Access Compliance Report Public Rights-of-Way (Curb Ramps)

Main Street: SKLAR_ST Cross Street: AVENDALE_BLVD Location: NE

ADA ID: RPRK211102172930 Ramp Type: Type 4 - Parallel Initial Pass/Fail: Fail Overall Compliance: No Severity Score: 32

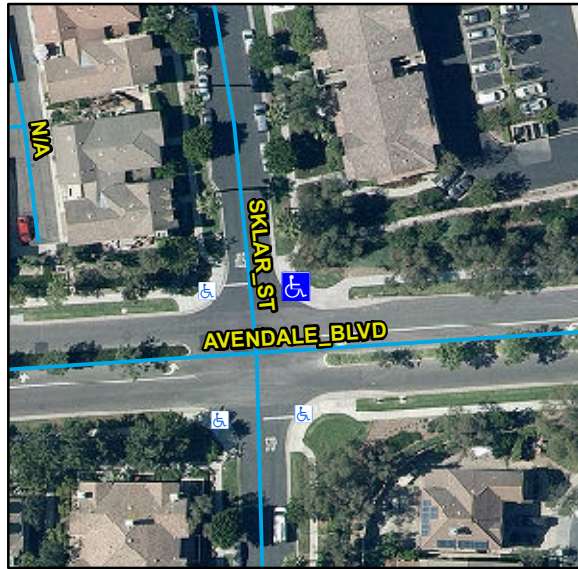
R204.3, R304.5.3, R304.3.2, STD 1115

Compliance	Description	Data	Compliance	Description	Data
N/A	Ramp Length LT (in)	140	N/A	Ramp Length RT (in)	124
Yes	Ramp Width LT (in)	90	Yes	Ramp Width RT (in)	90
Yes	Ramp Run Slope LT (%)	3.8	No	Ramp Run Slope RT (%)	18.5
No	Ramp Cross Slope LT (%)	3	Yes	Ramp Cross Slope RT (%)	0.6
N/A	Landing Present	N/A	N/A	DWS Provided	N/A
N/A	Landing Length (in)	N/A	N/A	DWS Contrast	N/A
N/A	Landing Width (in)	N/A	N/A	DWS Length (in)	N/A
N/A	Landing Run Slope (%)	N/A	N/A	DWS Full Width	N/A
N/A	Landing Cross Slope (%)	N/A		DWS Offset Type	N/A
N/A	Landing Movement Obstructed?	N/A	N/A	DWS Offset Left (in)	N/A
	Landing Movement Type	N/A	N/A	DWS Offset Right (in)	N/A
N/A	Landing Shared	N/A			
N/A	Clear Space	Yes			
N/A	Clear Space To Crosswalk (in)	N/A			
N/A	Marked Crosswalk 1	No	N/A	Marked Crosswalk 2	No
	Crossing 1 Direction	W		Crossing 2 Direction	S
	Marked Crosswalk 1 Width (in)	N/A		Marked Crosswalk 2 Width (in)	N/A

Remove & Replace Curb Ramp With Two New Directional Ramps or Equivalent.
